<b>Notice of Allowability</b>	Application No.	Applicant(s)	
	10/814,488	MYERS ET AL.	
	Examiner	Art Unit	
	Ehud Gartenberg	3746

### **EXAMINER'S AMENDMENT**

FIG. 11

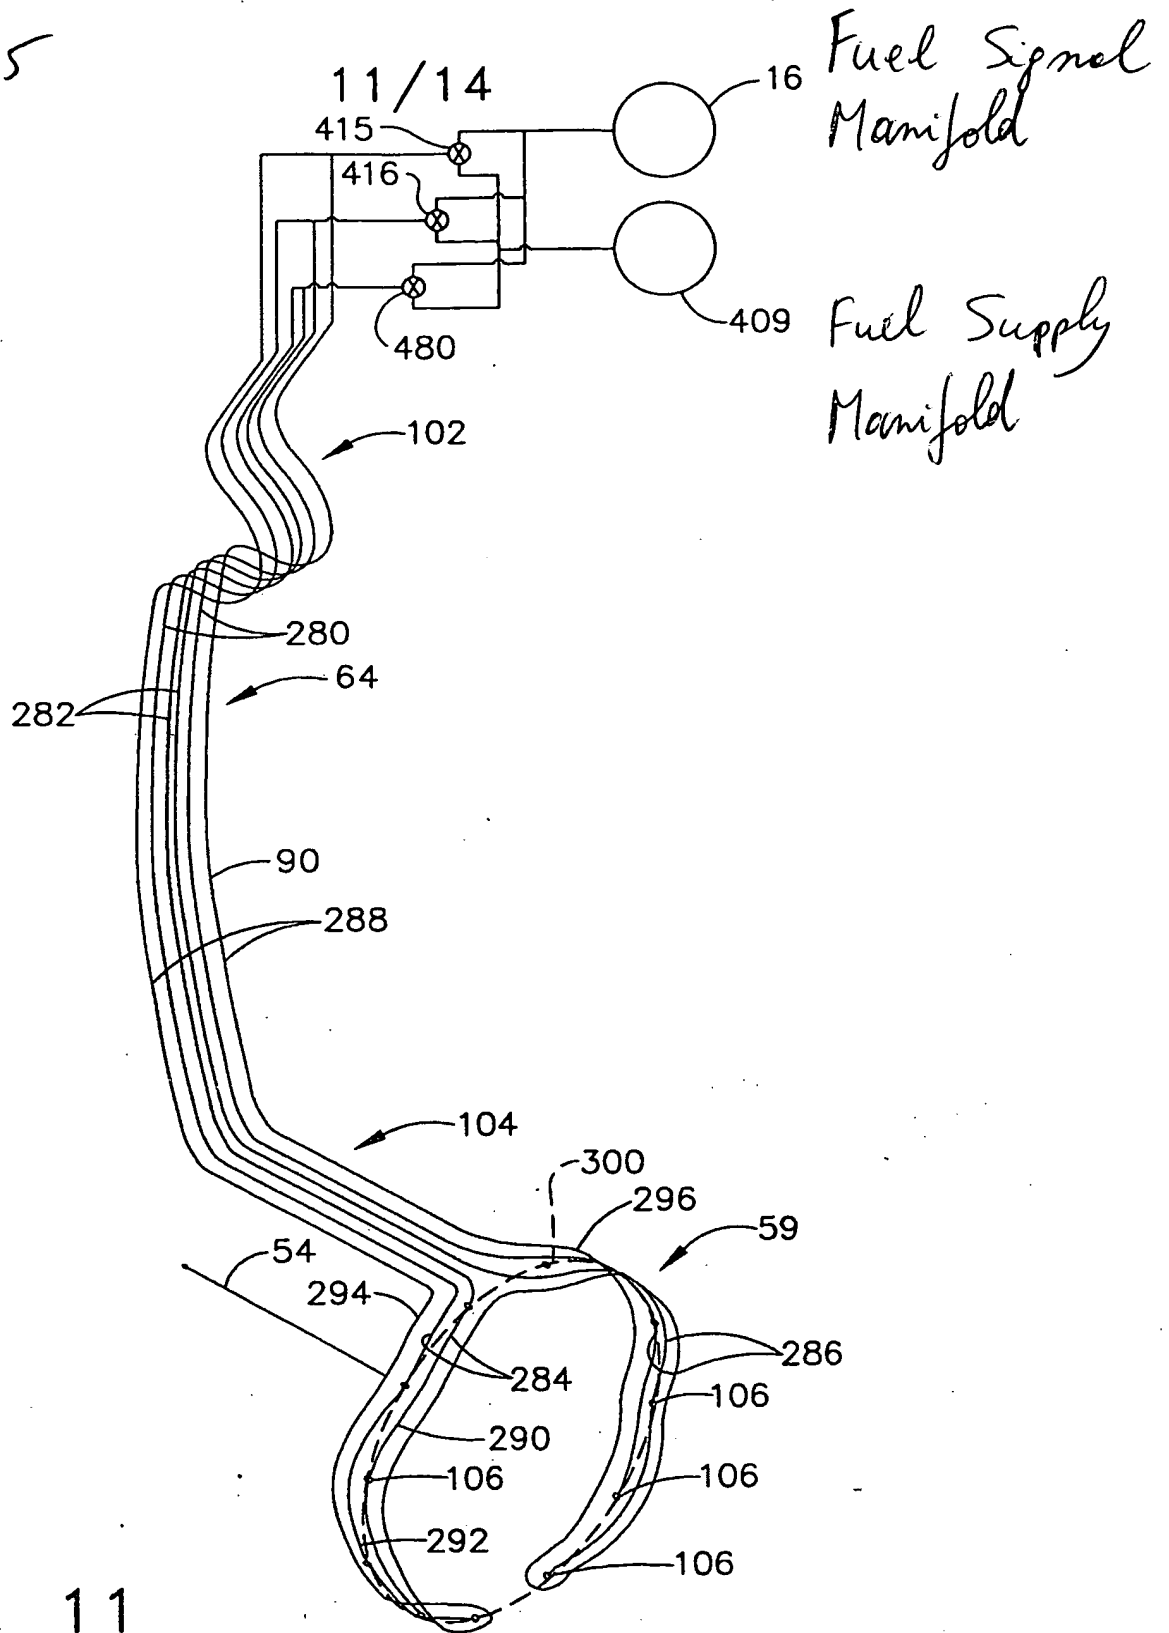
The application has been amended as follows: Figure 11 has been selected to be printed on the face of the patent, and has been amended by the Examiner to include and verbally explain some of the most important features and elements of the claimed invention.

2. New corrected drawing of Figure 11 in compliance with 37 CFR 1.121(d) are required in this application because Figure 11 has been amended by the Examiner. Applicant is advised to employ the services of a competent patent draftsman outside the Office, as the U.S. Patent and Trademark Office no longer prepares new drawings. The corrected drawings are required in reply to the Office action to avoid abandonment of the application. The requirement for corrected drawings will not be held in abeyance.

5. ☐ A SUBSTITUTE OATH OR DECLARATION must be submitted. Note the attached EXAMINER'S AMENDMENT or NOTICE OF INFORMAL PATENT APPLICATION (PTO-152) which gives reason(s) why the oath or declaration is deficient.
6. ☒ CORRECTED DRAWINGS (as "replacement sheets") must be submitted.
  - (a) ☐ including changes required by the Notice of Draftsperson's Patent Drawing Review (PTO-948) attached
    - 1) ☐ hereto or 2) ☐ to Paper No./Mail Date \_\_\_\_\_.
  - (b) ☒ including changes required by the attached Examiner's Amendment / Comment or in the Office action of Paper No./Mail Date FIGURE 11 ONLY.
